From: Oswald Jr, Woodin
Sent: Tuesday, December 10, 2024 8:35 AM
To: jim@jnmengineeringllc.com
Subject: Rev #1 Plan Review Comments_11935 Simpson Road

The OSDS Plan (revision #1) for 11935 Simpson Road has been reviewed with the following comments:

11935 SW SIMPSON ROAD
CLARKSVILLE, MD 21029
LOT 7, PLAT 14485, MAP 41
GRID 7, 1.12 ACRES, ACCT#05-434351
ONSITE SEWERAGE DISPOSAL
SYSTEM DESIGN PLAN

Proposed 2-Story House #11935 Simpson Rd. FF: 507.30' LL: 497.42' Gar: 504.9'

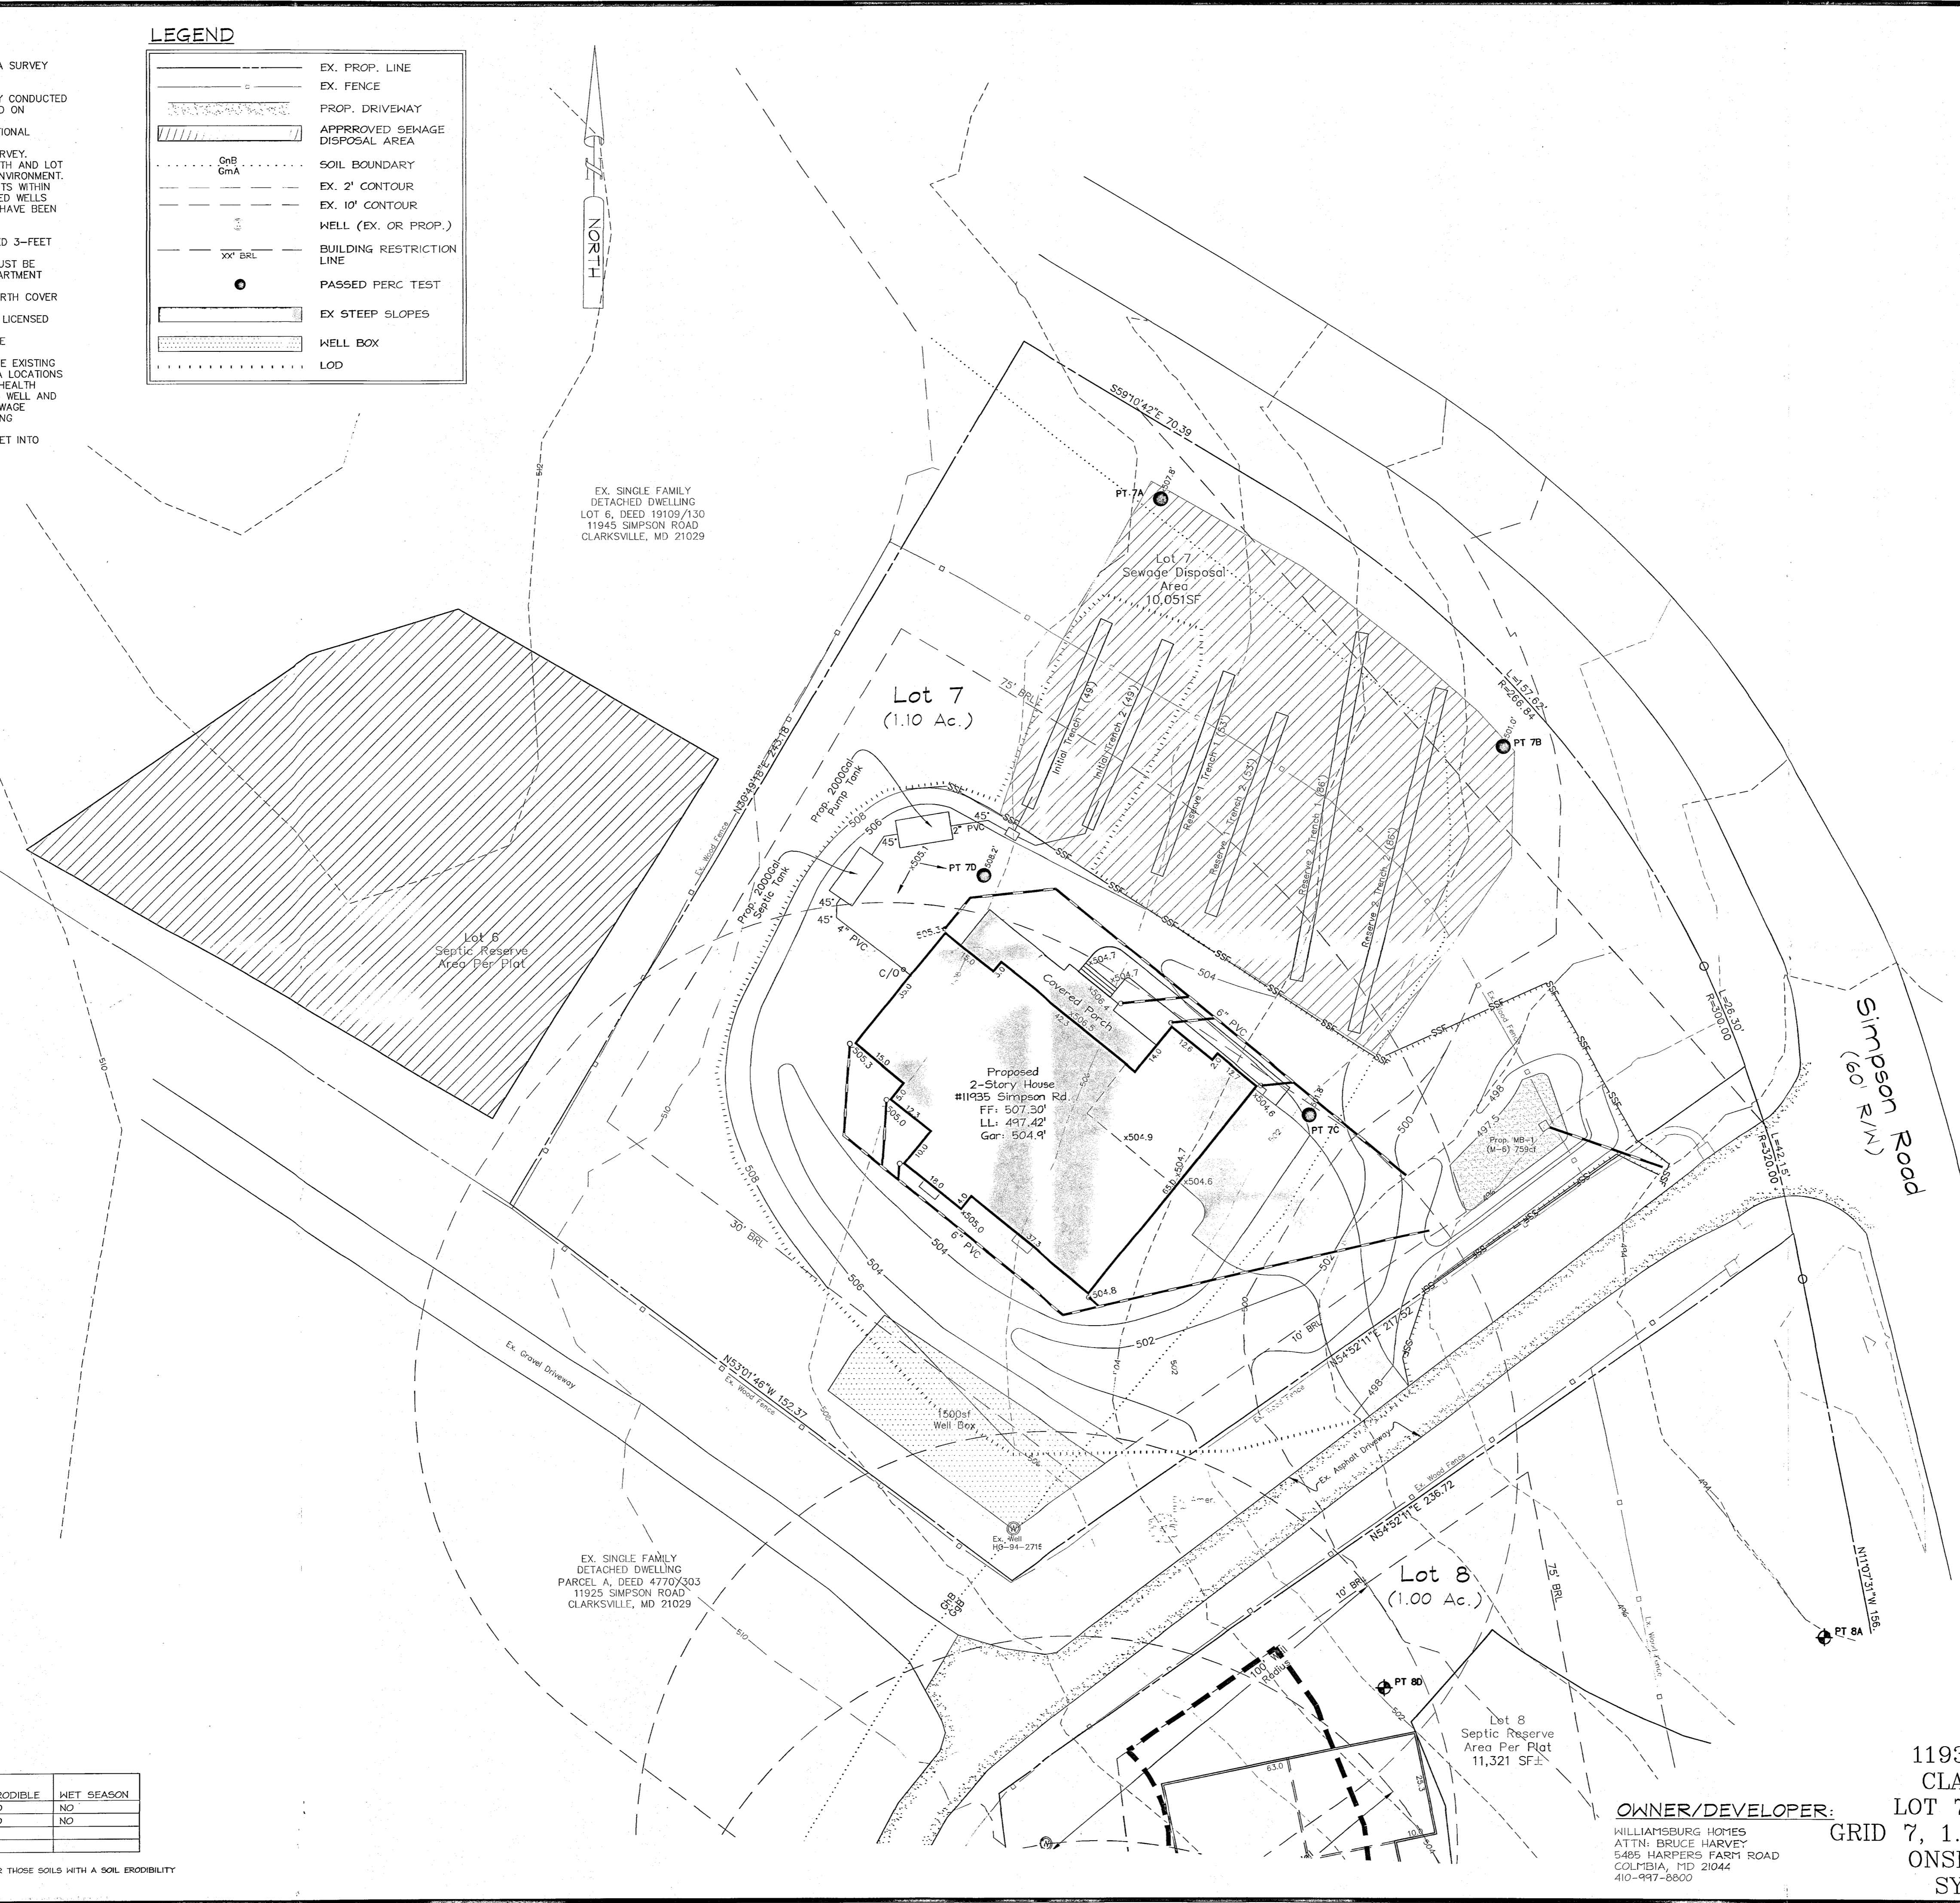
It was brought my attention that the house foot print shown on the OSDS Plan did not include the conservatory. Would you be able to revise the OSDS Plan to show the conservatory and submit two copies for the file? That's the only change.

Septic System Profile
HOR.: 1"=30'
VERTICAL: 1"=3'

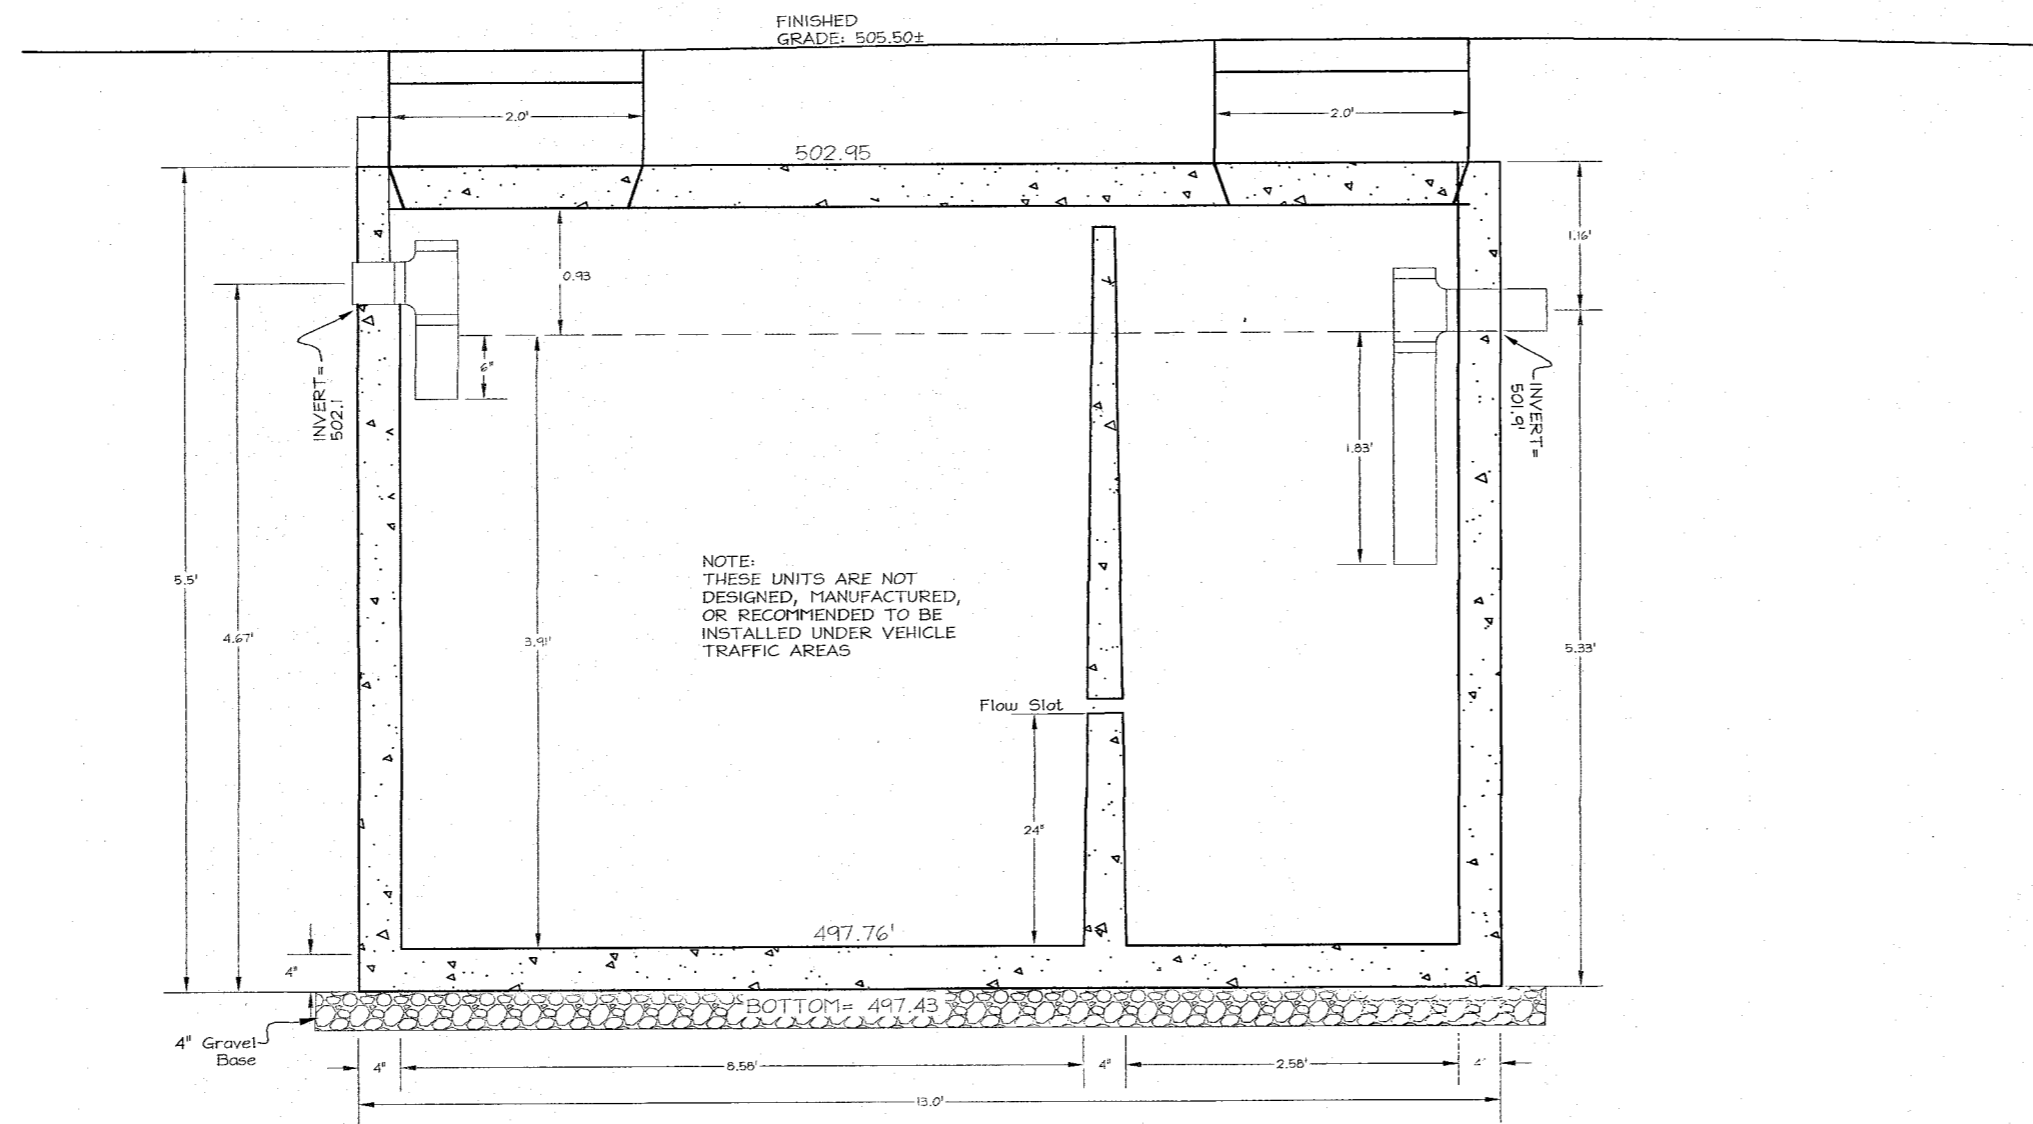
1. Both tanks still exceed 3 feet in depth.
2. The design point is beyond the end of the pump curve. It's best to choose a pump where the design point is more towards the center of the curve, but not above. A 1/3 hp should be adequate. You may want try a different manufacturer.
3. The elevation # in the *distribution box detail* still don't match the elevation # in the *septic system profile*.
